MEETING NOTICE
TUALATIN ARCHITECTURAL REVIEW BOARD
August 13, 2014, 6:30 PM
Addendum Item 4B
POLICE TRAINING ROOM
8650 SW TUALATIN RD
TUALATIN, OR 97062

River Ridge Apartment Complex Addendum

Addendum memo as a result from August 8, 2014 submittal from applicant. The applicant has provided documentation that meeting codes is feasible with the current proposal and conditions of approval. This additional information is attached for your reference.

SITE PLAN **A1.1**
AUGUST 7, 2014

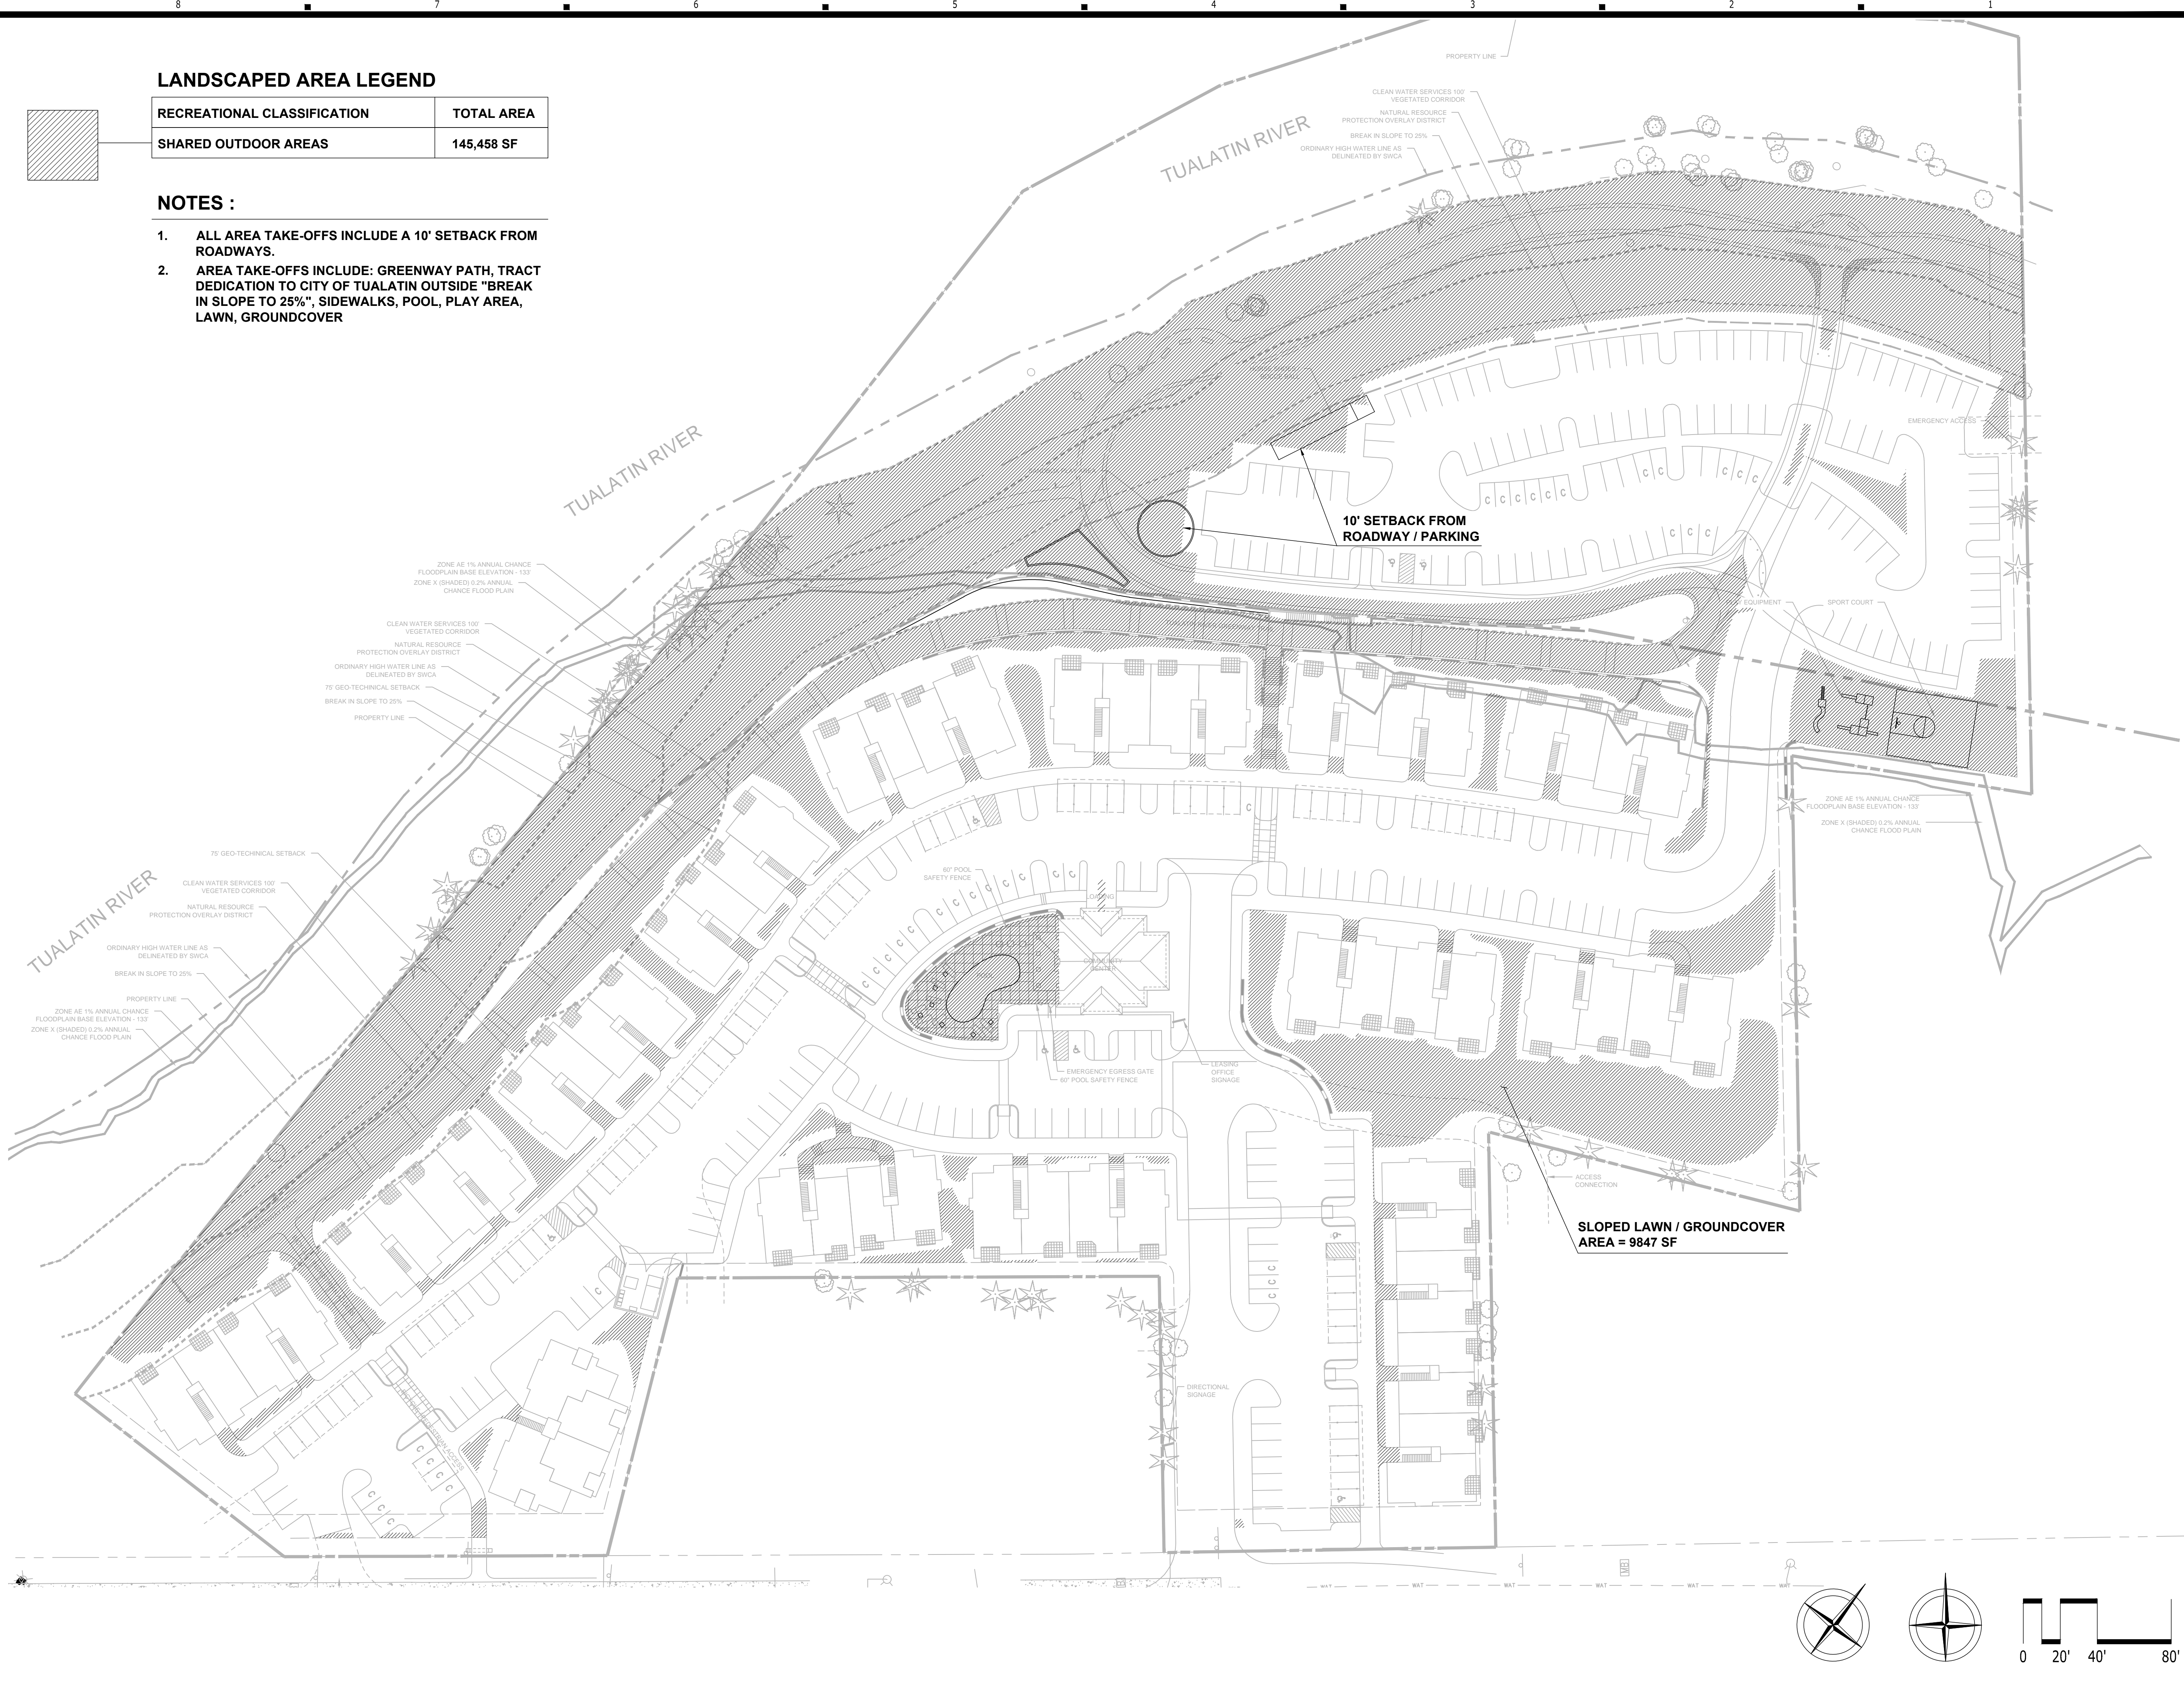
1. Recreational Area Requirement: Staff had not been provided evidence that it was feasible to provide the 81,000 square feet of recreational area and the 27,000 square feet of children's recreational area. On August 8, 2014 the applicant provided an exhibit (Sheet L3.0) showing that the applicant is providing 145,458 square feet of recreational area. Some of this areas are steep slopes, trees, and shrubbery. However, staff believes that the applicant can prove there is enough usable recreational area given the excess of square footage provided.

- 1. Recreational Area Requirement:** 81,000 square feet of recreational area including 27,000 square feet of children’s recreational area need to be provided. Landscape drawing L3.0 was presented showing 177,456 SF of recreational area and 33,139 SF of children’s play area are provided. A rough area takeoff during the meeting confirmed the approximate area of the children’s play area. A more precise takeoff of the areas has been done reflecting the current revised site plan and is shown on the attached revised L3.0 & L3.1 drawing. A total of 145,458 SF of outdoor recreational area is provided. Of that, 32,662 SF if is children’s play area.

Date: Friday, August 08, 2014 11:15:42 PM / Location: \\kls-srv\kls\ACTIVE\COMMERCIAL CLIENTS\109 River Ridge\drawings\Drawing sheets\L3.1 CHILDRENS OUTDOOR RECREATIONAL AREAS.dwg / User: Deven Young / Layout: L3.0 OUTDOOR RECREATIONAL AREAS

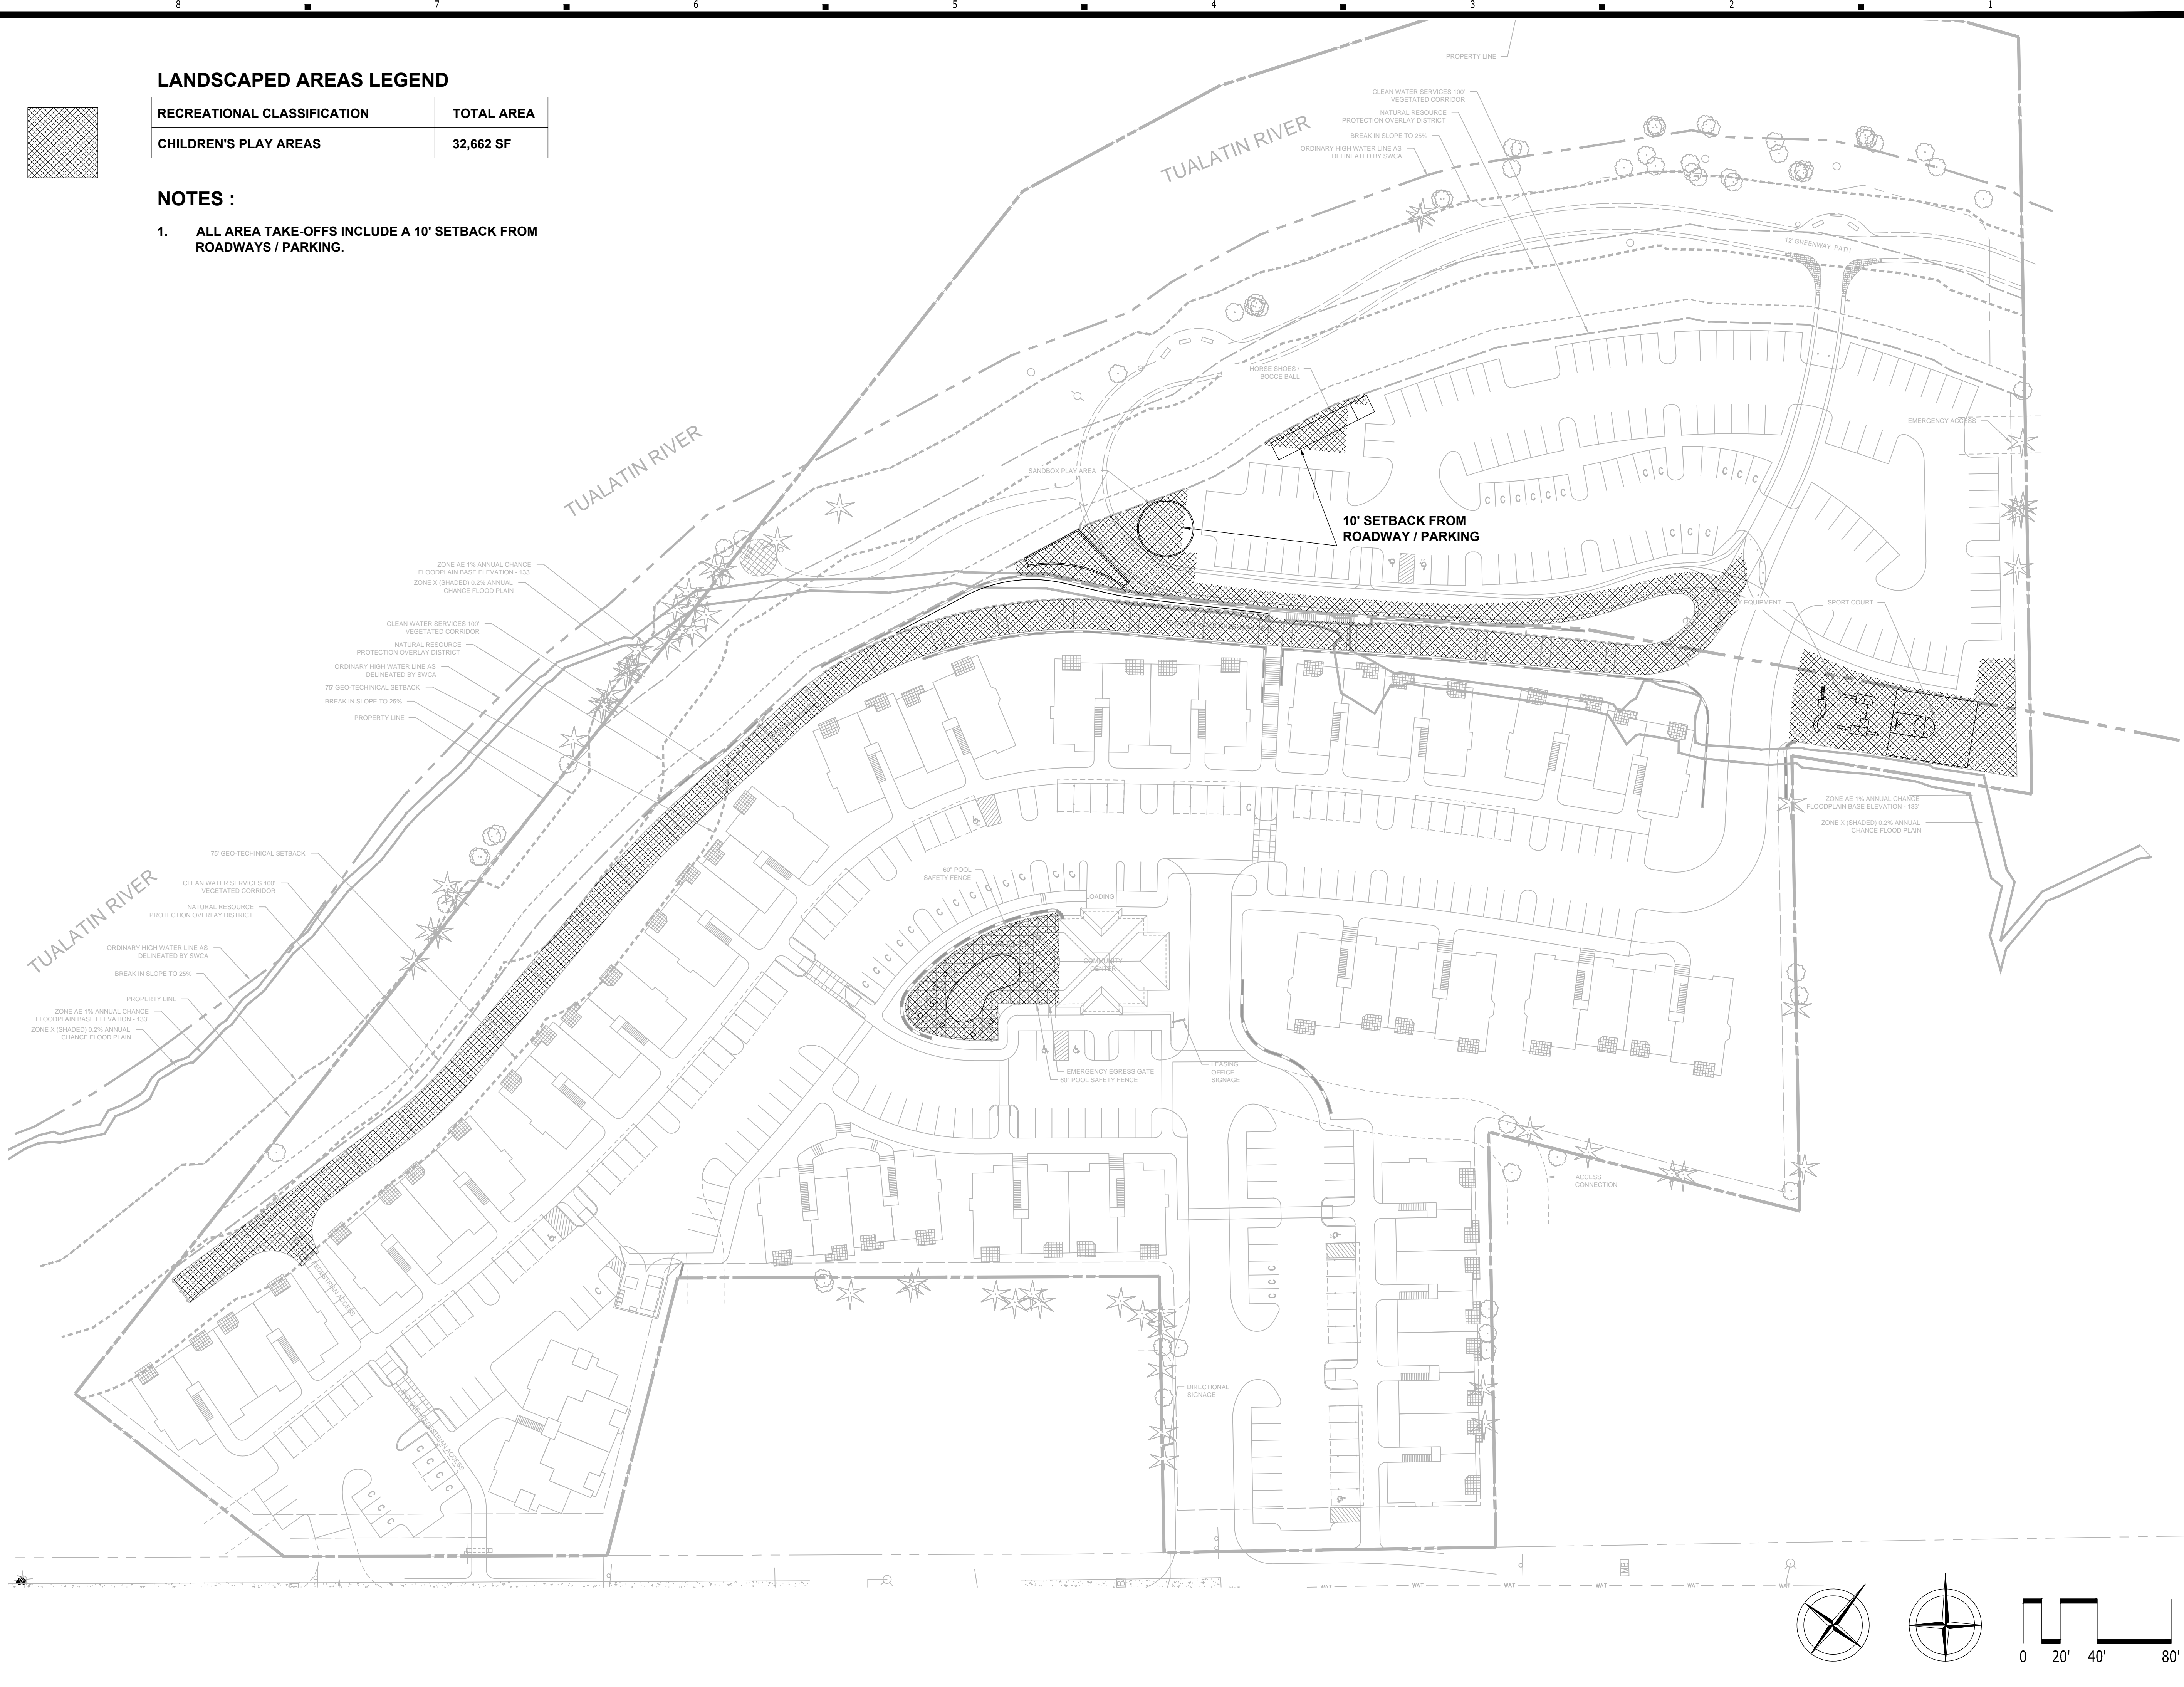
Sheet L3.1 from the August 8th submittal shows the applicant is providing 32,662 square feet of children's play area. It appears that all of the children's play area square footage shown is usable. Staff recommends the applicant be conditioned to provide the proposed sand box, bocce ball, horse shoes, jungle gyms, and basketball court in the sizes shown.
